Delegated Report

Householder Planning Application

Planning Application No: 20211144

Description: Creation of a vehicle crossover.

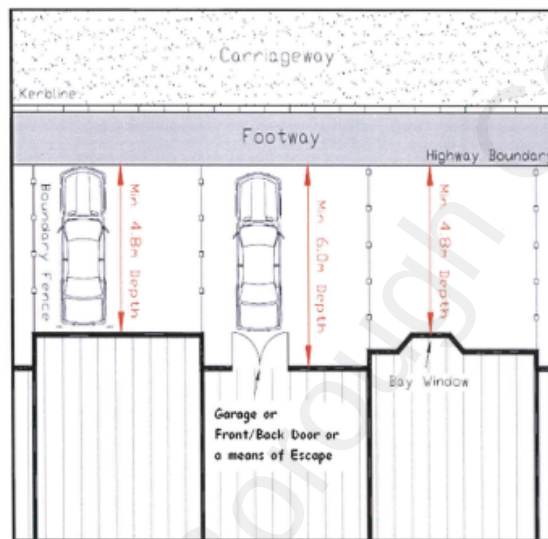
Here the front garden is only 4.8 metres deep and so whilst it may comply with the minimum depth guidance it does not provide the 6 metres required in front of the front door. Also the width of 4.8 metres is restrictive for two vehicles, as there is no space to borrow from adjacent parking spaces where the boundary walls are. SPG4 suggests that parking spaces should be widened to 2.7m when it adjacent to an enclosed boundary. Therefore the driveway would only be suitable for a single vehicle and for this a 3.750 metre dropped kerb would appear excessive. 2.8 metres should be sufficient, 3 dropped kerbs plus the wings and this should be offset from the centre of the property so that the vehicle is parked away from the pedestrian route to the front door.

The hardstanding is insufficient and contrary to the above and Kent County Council's parking standards (SPG 4) which states a space should have a minimum depth of 5m and where there is a front door the depth increases to some 6m. The proposal does not provide a detailed parking plan so it is not clear how many vehicles the applicant wishes to park on the drive. However if it is the case that a vehicle is intended to be parked in front of the front door then the required driveway depth should be 6m.

The depth of the proposed driveway would be 4.8m and is therefore substandard, meaning that vehicles will overhang the boundary onto the footpath of the application property's curtilage.

As can be seen from the Google Maps Image (April 2021) a vehicle parked on the driveway overhangs the front driveway.
